HISTORIC AND DESIGN REVIEW COMMISSION

February 05, 2020

HDRC CASE NO:	2020-029
ADDRESS:	102 BUFORD
LEGAL DESCRIPTION:	NCB 1369 BLK 6 LOT N 83 FT OF 11
ZONING:	R-4, H
CITY COUNCIL DIST.:	2
DISTRICT:	Dignowity Hill Historic District
APPLICANT:	Bruce Lizalde
OWNER:	Bruce Lizalde
TYPE OF WORK:	Addition, maintenance, porch modifications
APPLICATION RECEIVED:	January 11, 2020
60-DAY REVIEW:	March 10, 2020
CASE MANAGER:	Huy Pham

1. Replace the existing wrought iron porch columns with wood porch columns.
2. Replace the existing fiberglass door with a new fiberglass door.
3. Construct a 336 square foot rear addition.

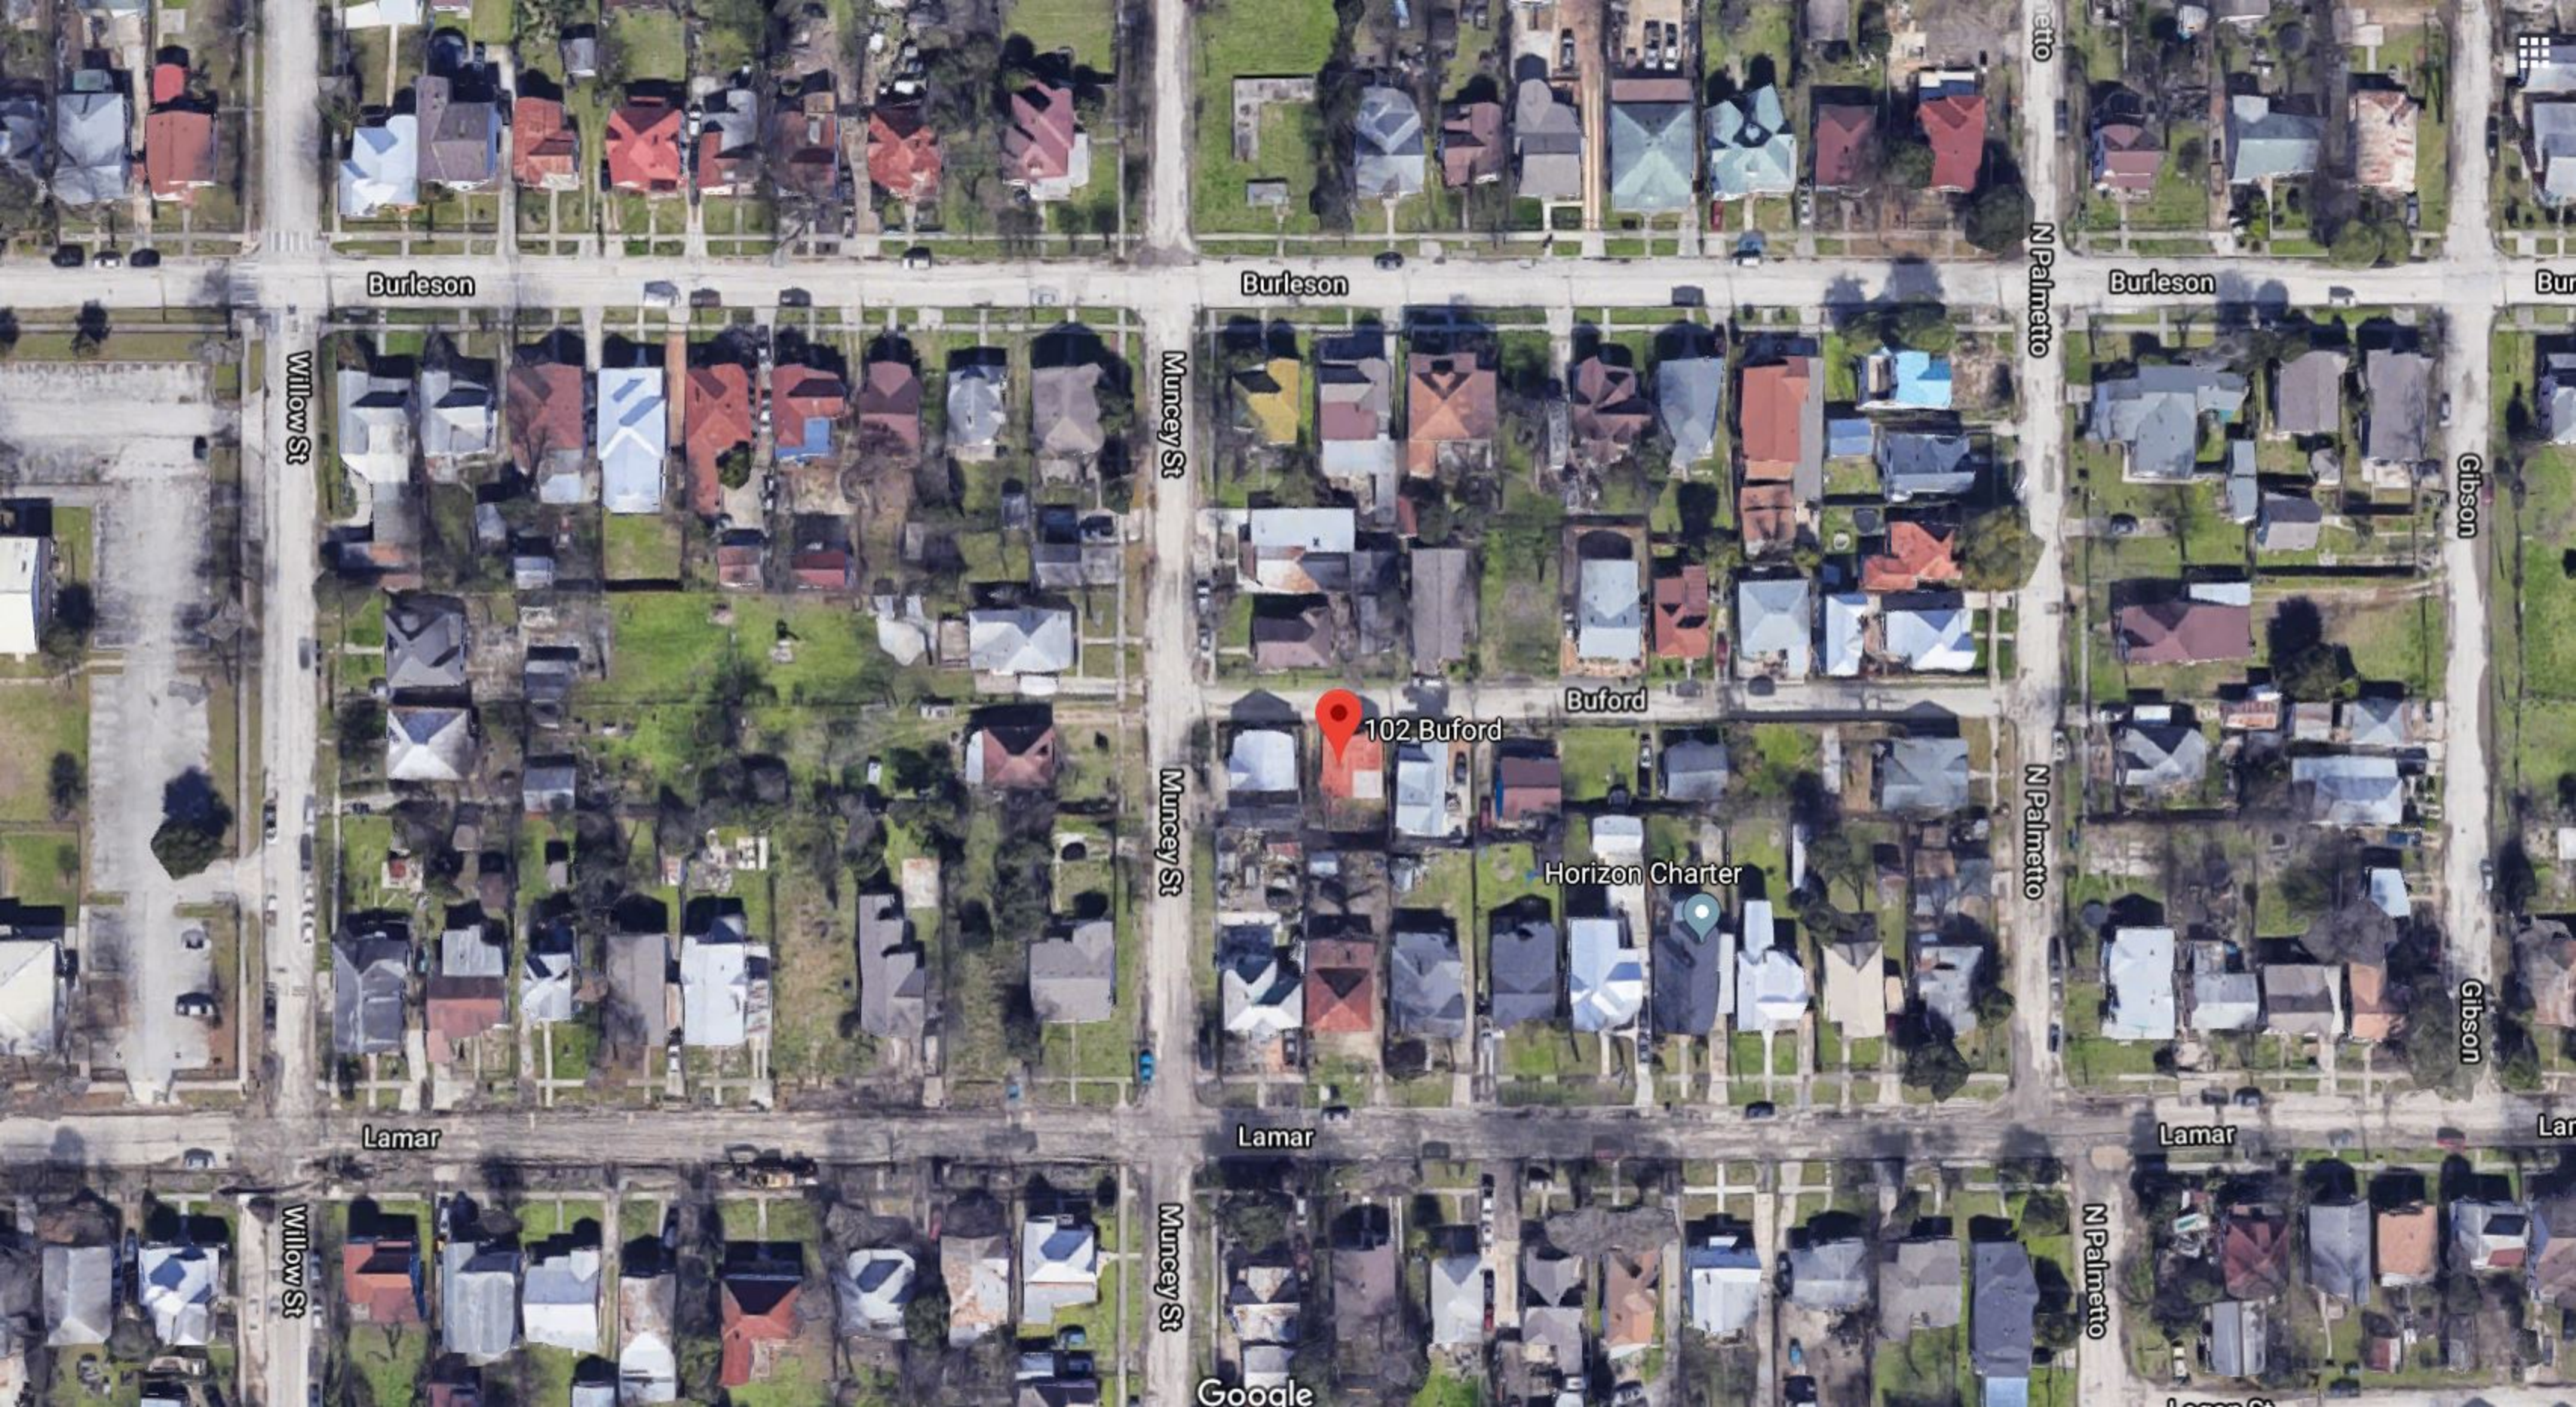
COMPLIANCE – On a site visit on January 29, 2020, staff found that the rear elevation was subjected to window and siding removal in preparation for the proposed addition, prior to approval. At this time, no known historic material has been discarded.

FRONT PORCH ELEVATION

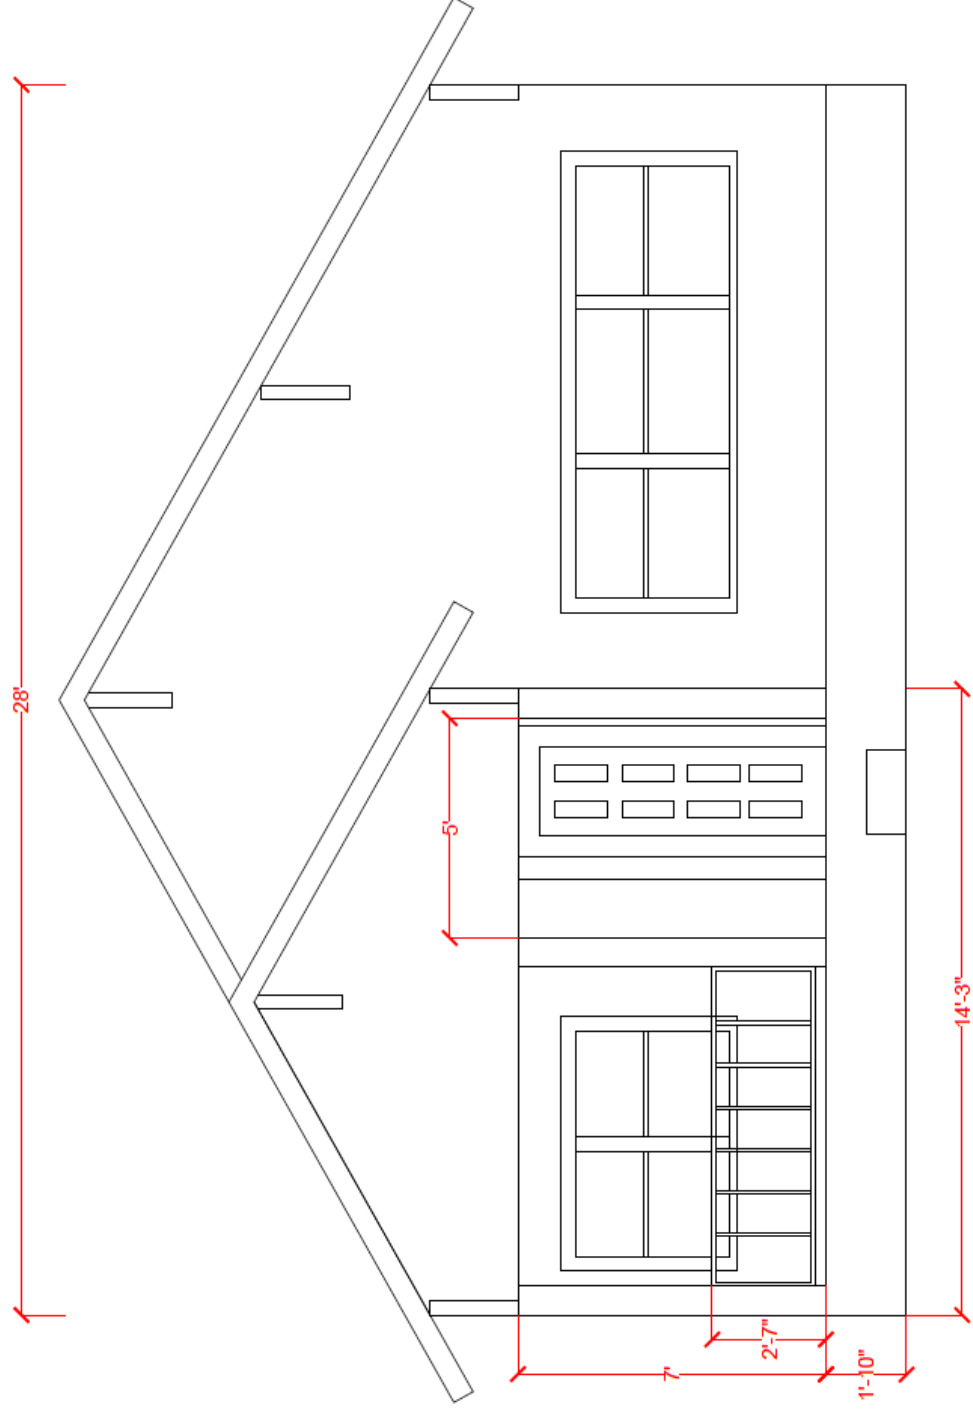
- c. COLUMN REPLACEMENT – The applicant has proposed to replace the wrought columns porch columns with square columns with capital and base trim. Per the Guidelines for Exterior Maintenance and Alterations 7.B.iii., applicants should replace in-kind porches, balconies, porte-cocheres, and related elements, such as ceilings, floors, and columns, when such features are deteriorated beyond repair. Staff finds that the wrought iron columns are not original to the structure and are eligible for replacement with wood columns that are typical to that of Craftsman style houses including the following details: The proposed wood columns should be no wider than 6' square, feature both capital and base trim and chamfered corners.

- i. That the proposed wood columns be no wider than 6' square, feature both capital and base trim and chamfered corners.
- ii. That the new improve upon the non-conforming feature by featuring a Craftsman door configuration, regardless of material. A door design must be submitted to staff prior to installation.
- iii. The proposed new windows must adhere to *Standard Specifications for Windows in Additions and New Construction*; faux divided lights and nailing fins should be avoided, regardless of material. The proposed Plygem windows do not meet standard specifications. A compliant window product must be submitted to staff prior to installation.
- iv. That the proposed composite siding feature an exposure of four (4) inches, a width of $\frac{3}{4}$ ", mitered corners, and a smooth finish.
